Tandler Gearbox Retrofit

TIP Z024-0001

Gravure Print Decks

Machine Model for Improvement: Zerand Gravure Print Decks

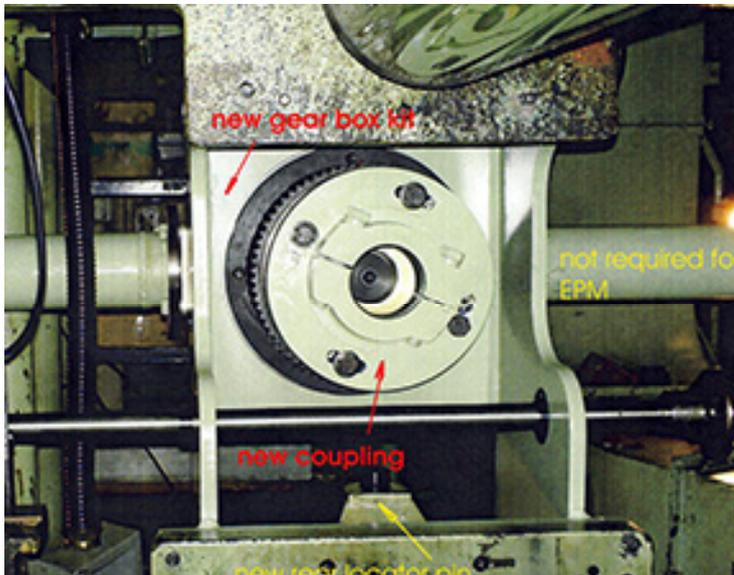
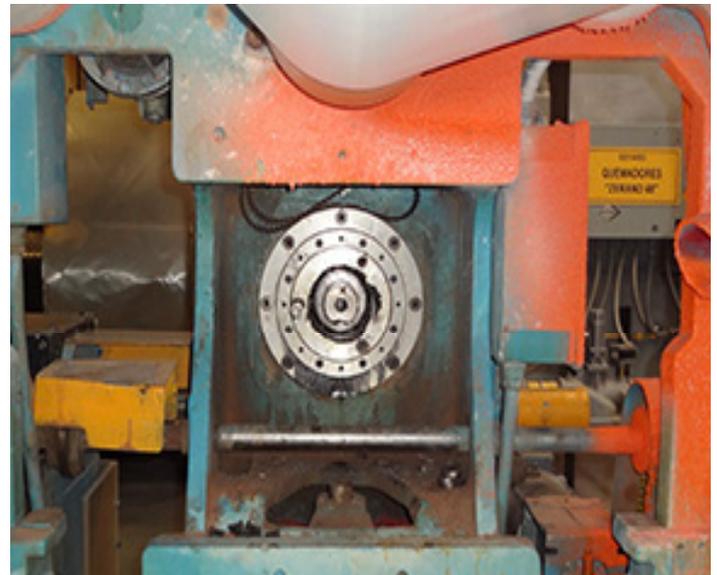
This improvement replaces the existing obsolete gearboxes with new commercially available Tandler gearboxes.

This improvement includes new torque tubes, couplings and mounts for the gearboxes.
